## COUNTY ROAD PROPOSED CROSSING

Edwardsburg Bridge No. 8  
County Road No. 22  
Hwy. 401 District #9

W.P. 132-59

Edwardsburg Bridge #8  
At County Rd. No. 22,  
Hwy. #401 Dist. #9,  
W.P. 132-59.

HWY. 401 LINE 'B' - DISTRICT 9	COUNTY GRENVILLE
TOWNSHIP EDWARDSBURG	LOT 46.1 CON. II
LOCATION R.R. 2 MI. N. OF CARDINAL	
DRAWN BY: T. MELLORS	CHECKED BY: J. H.
DATE: 3 MAY 1960	APPROVED BY: J. H.
SCALE: 1 IN. = 20 FT.	W.P. 132-59 DRAWING NO. 60F-28A

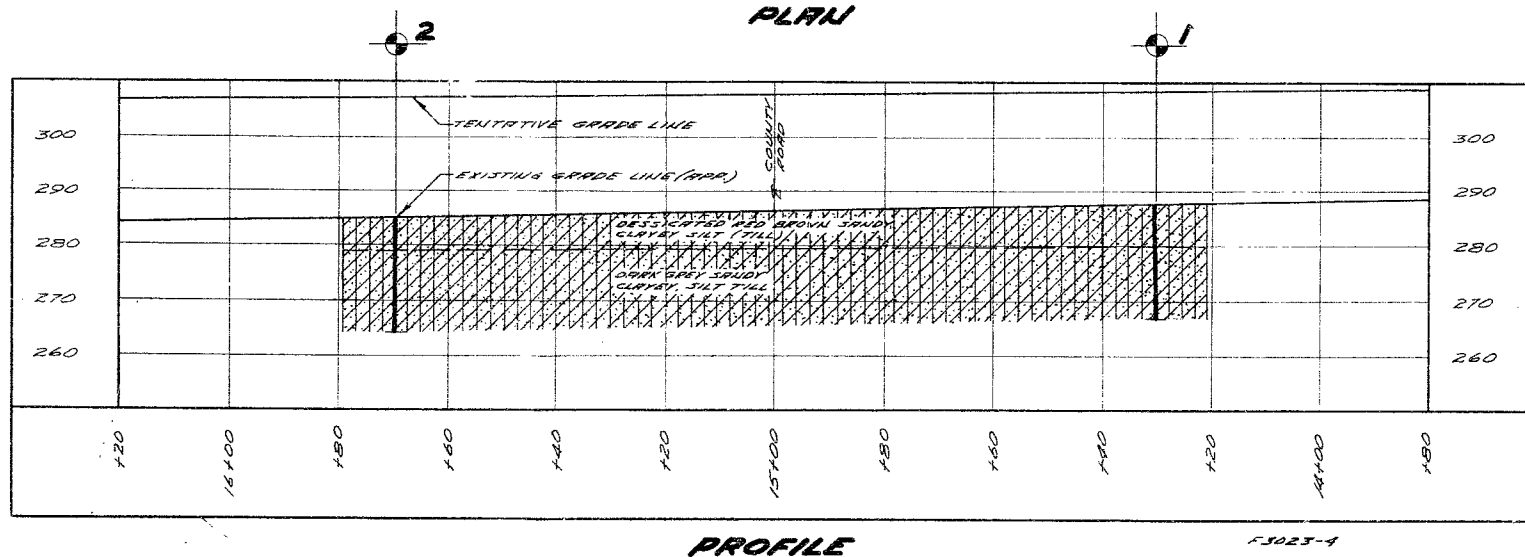
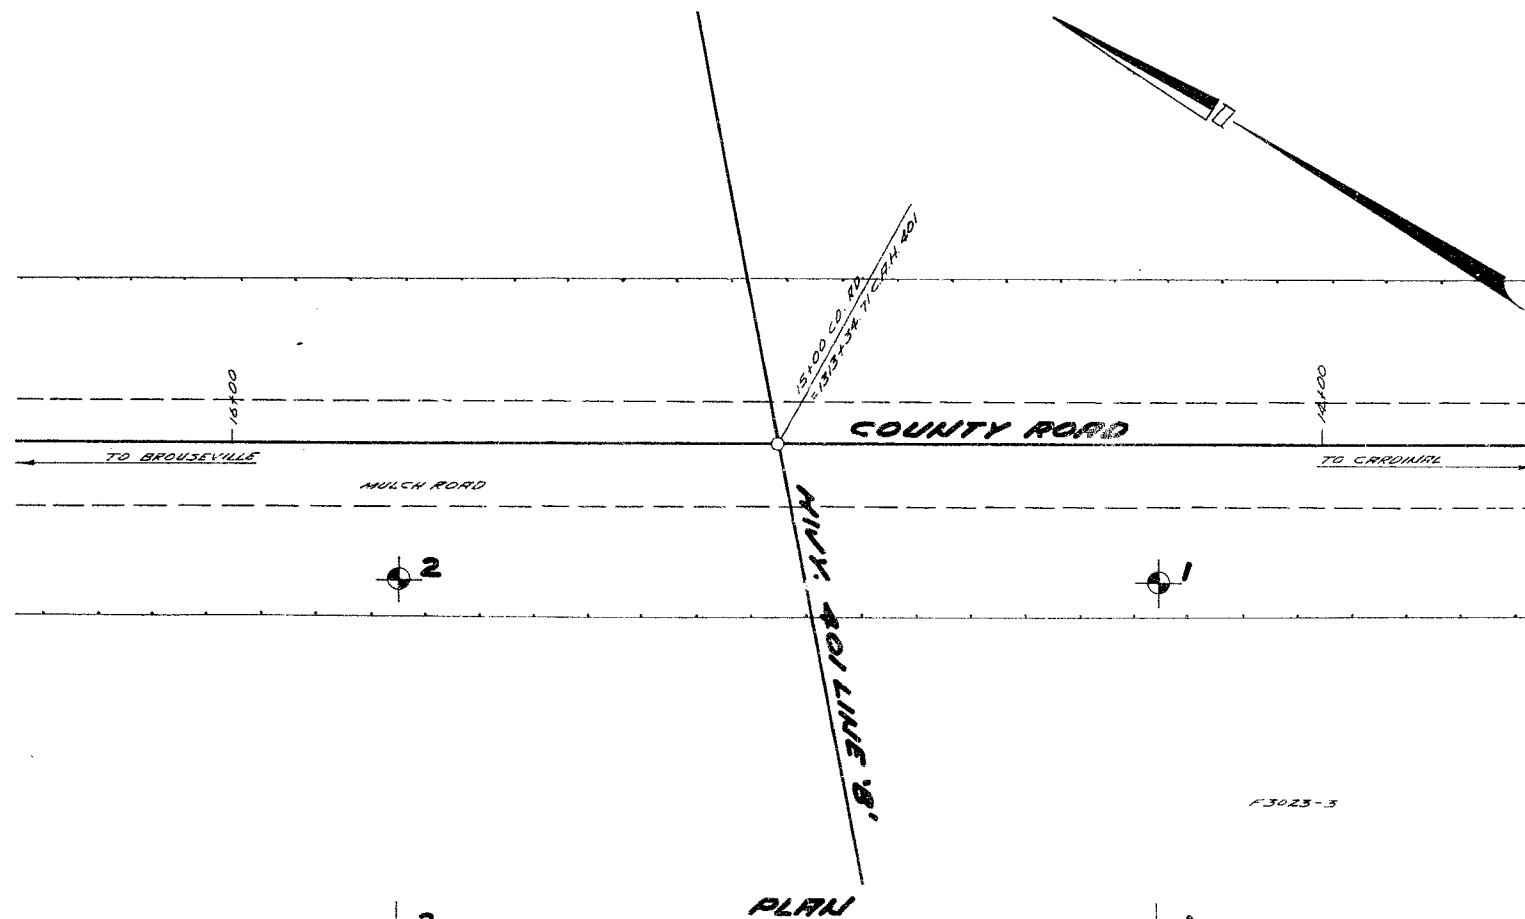
THE BOUNDARIES BETWEEN SOIL STRATA HAVE BEEN ESTABLISHED ONLY AT BORE HOLE LOCATIONS. BETWEEN BORE HOLES THE BOUNDARIES ARE ASSUMED FROM GEOLOGICAL EVIDENCE AND MAY BE SUBJECT TO CONSIDERABLE ERROR.

LOGS OF BORINGS

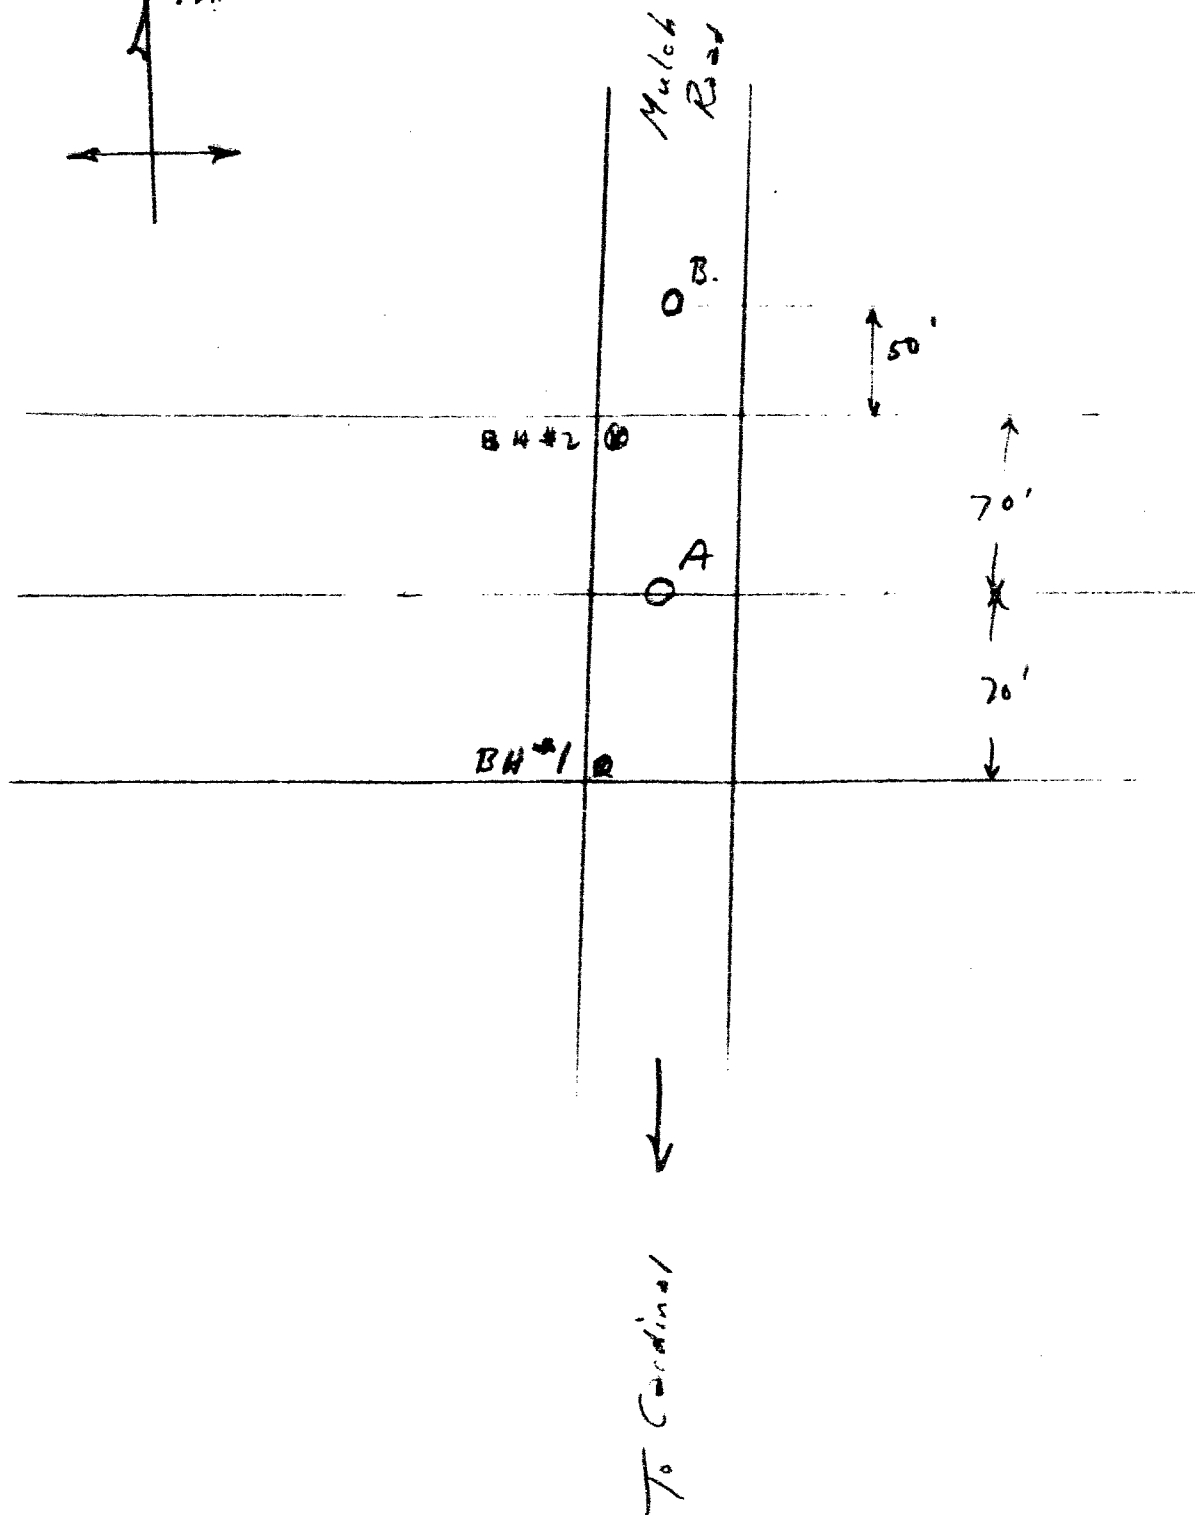
Note:      These holes were placed as shown on the sketch accompanying.  
The original ground surface was a great deal higher than the  
datum for the present holes.
